TRACT NO. 50919  
 INDEX MAP 2257  
 SCALE: 1" = 600'  
 P.C. 11207

PROFILE, ALIGNMENT AND GRADE OF  
**SANITARY SEWERS**  
 TO BE CONSTRUCTED IN  
 TRACT NO. 50919

SCALE: HORIZ. 1" = 60' VERT. 1" = 6'  
 FEB. 1992

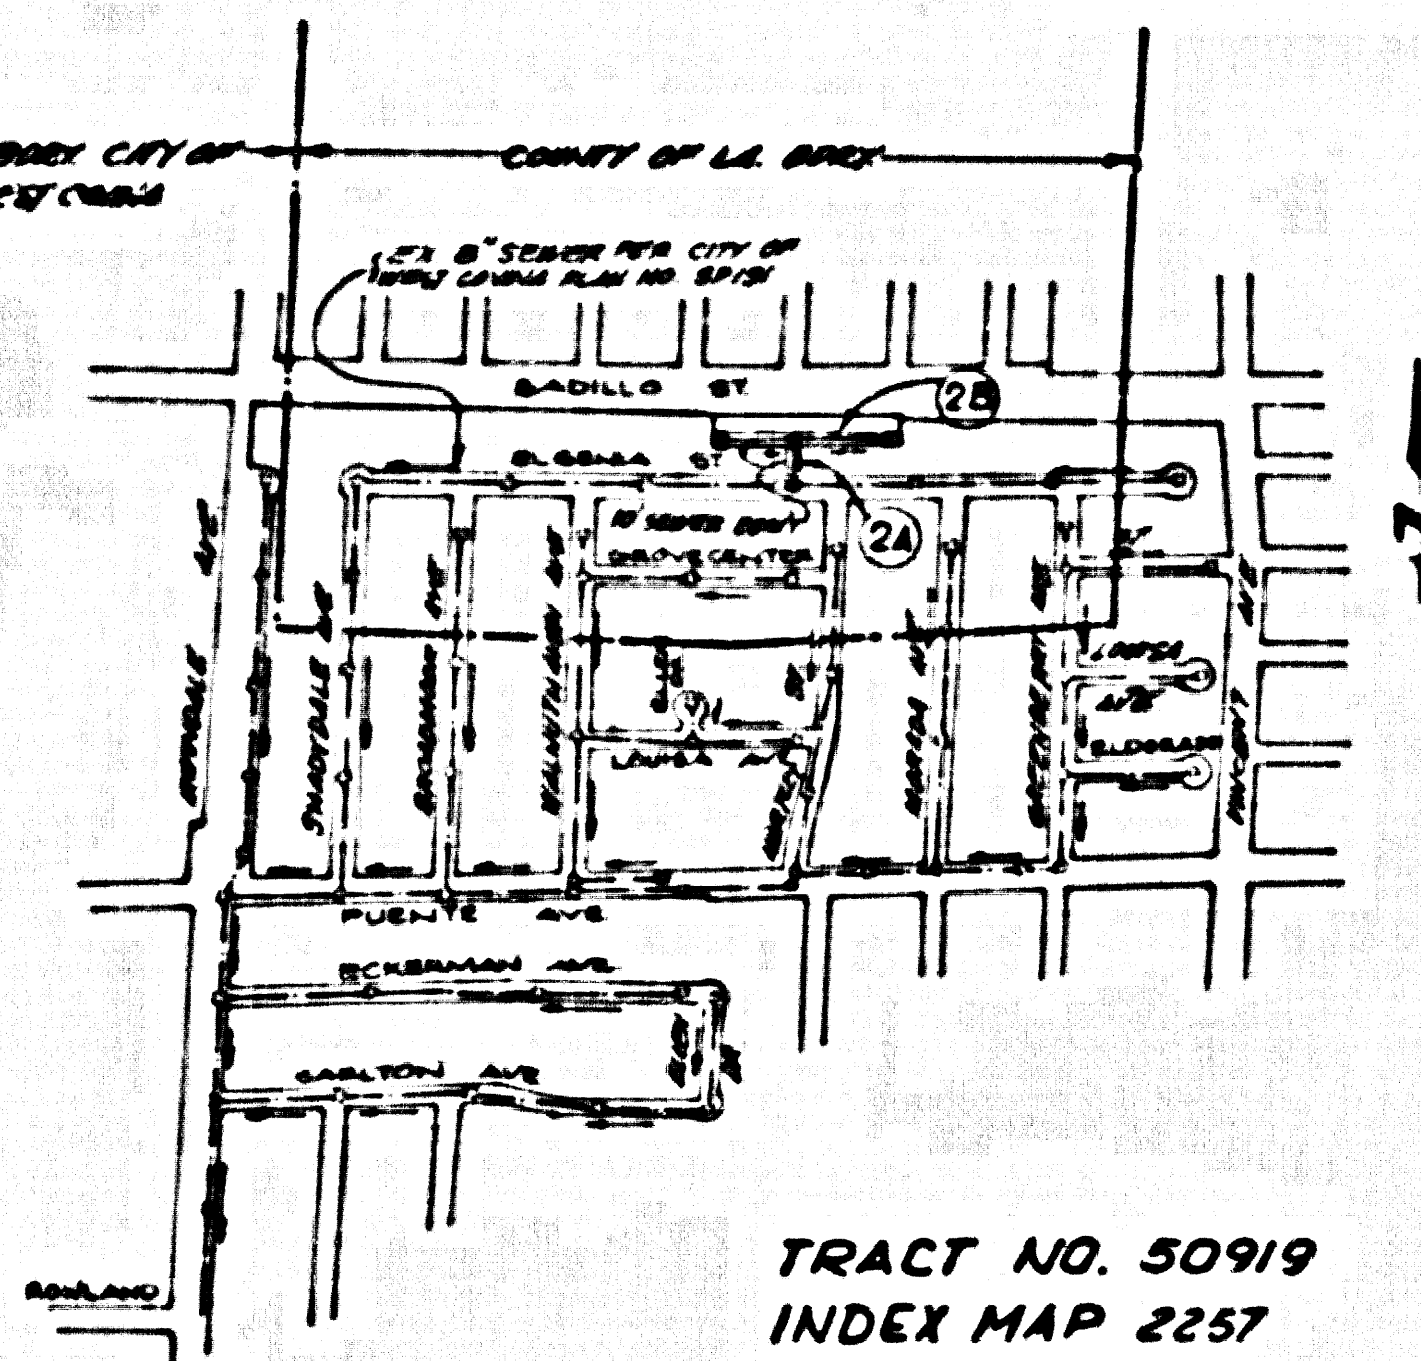
REVISION NO.  $\Delta$  DATE: 6/10/93  
 REVISED STATIONS, DISTANCES, ELEVATIONS, AND  
 ADDED B'S STUBS AS SHOWN HEREON,  
 PER 'AS-BUILT' PLAN.  
 APPROVED: *Sally Gilroy* 6/30/93  
 DIST. OF PUBLIC WORKS
